## **Stage 1 Road Safety Audit**

**Ballyfasy Wind Farm, Co Kilkenny**

On behalf of **Manogate Ltd**

**October 2025**

#### 4.1.6 Junction Visibility Splays

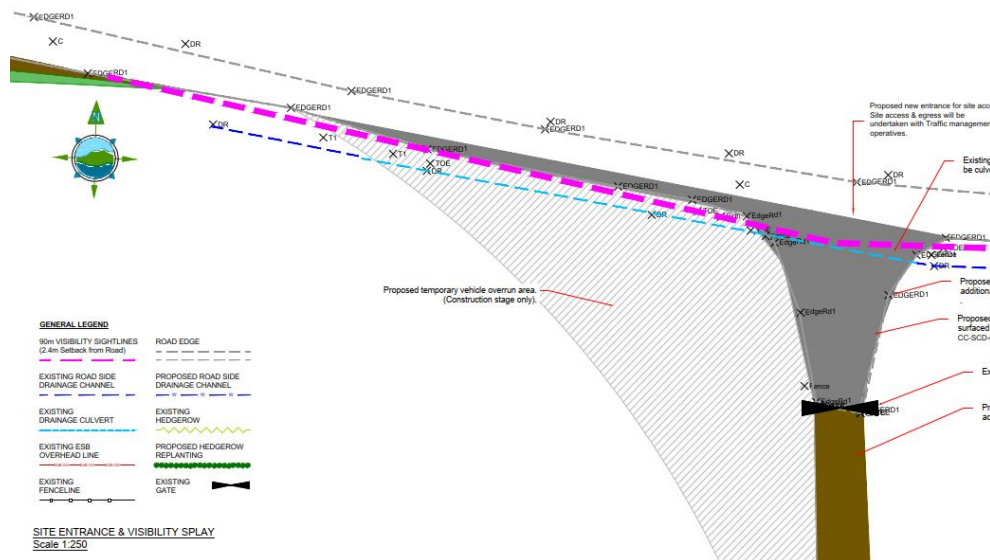
**Problem:** All junction visibility splays are indicated as 2.4 x 90m. During the site visit very few vehicles were observed and therefore it was difficult to estimate the existing vehicle speeds on these roads, however there is concern the visibility 'Y' distance is not suitable for the speed of vehicles on some of the roads.

**Hazard:** Users may exit the development junction(s) into the path of unseen oncoming traffic. Impacts may result.

**Recommendation:** The Design Team should ensure the junction visibility splays are appropriate for the public road traffic speed.

#### 4.3.7 Lighting Columns / Signage within the Vehicle Swept Path

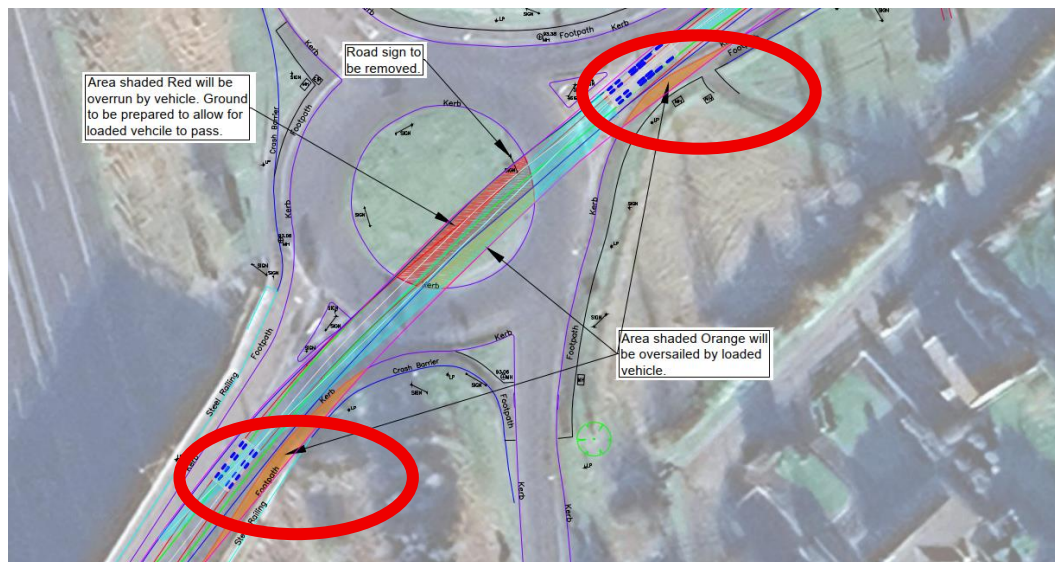
**Problem:** There are some locations where lighting columns and / or signage is located within the vehicle swept path and is not identified to be removed. There is concern the delivery vehicle team will be required to stop and wait while these elements are removed, therefore delaying completion of the turbine delivery.

**Hazard:** Increased duration of road closures and diversions may result in collisions by diverted traffic.

**Recommendation:** The Design Team should ensure all obstructions to the delivery vehicle are removed prior to arrival of the convoy.

#### 4.3.9 Field Boundary Fencing / Gates

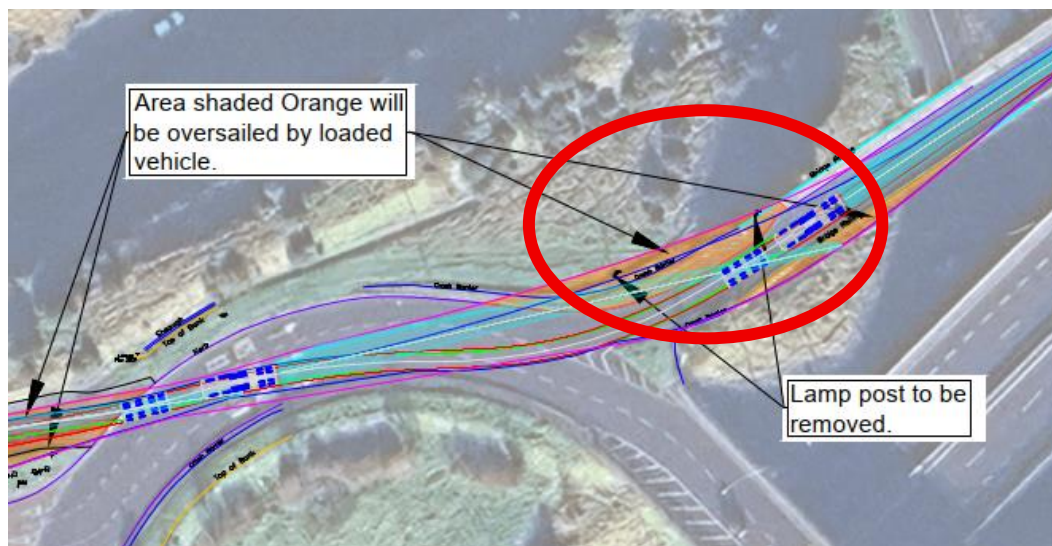
**Problem:** There are areas of field boundary fencing (and possibly gates) shown to be removed by the works. There is concern livestock may escape onto the carriageway.

**Hazard:** Motorists may lose vehicle control when attempting to avoid impact with livestock.

**Recommendation:** The Design Team should ensure all livestock is contained throughout the delivery and suitable secure fencing is replaced upon completion.

#### 4.4.2 Location 10

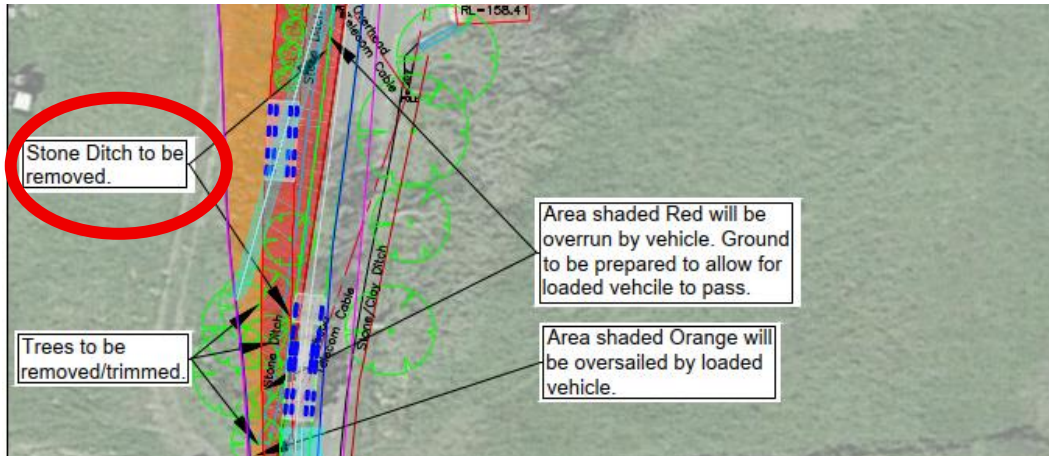
**Problem:** The existing roadside stone ditch is proposed to be removed by the works. There is concern removal of this ditch will result in surface water flooding of the adjacent carriageway.

**Hazard:** Aquaplaning type collisions may result.

**Recommendation:** The Design Team should ensure suitable drainage systems are installed to replace the stone ditch.

#### 4.4.3 Location 13 – Utility Pole Stay

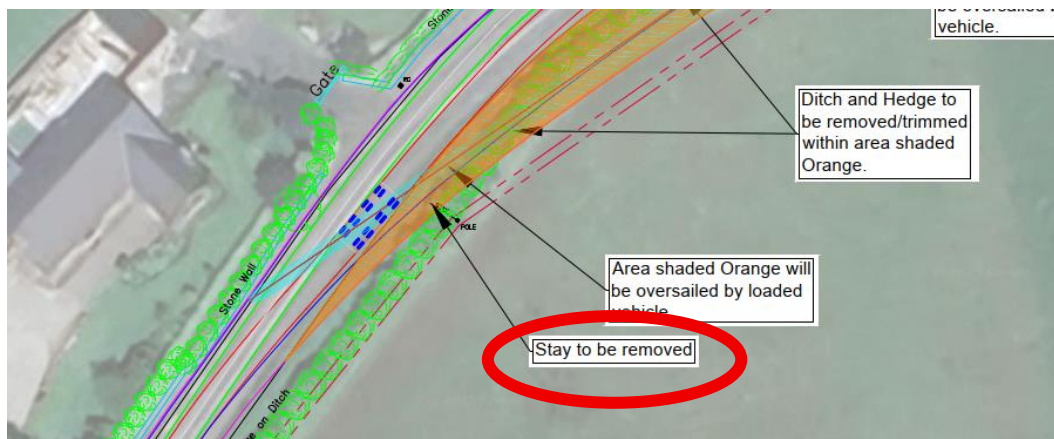
**Problem:** There is a utility pole stay indicated to be removed by the works. Removal of this stay may result in the associated pole and cable falling into the carriageway.

**Hazard:** Impact from passing traffic may result.

**Recommendation:** The Design Team should ensure the pole and cable are secure.
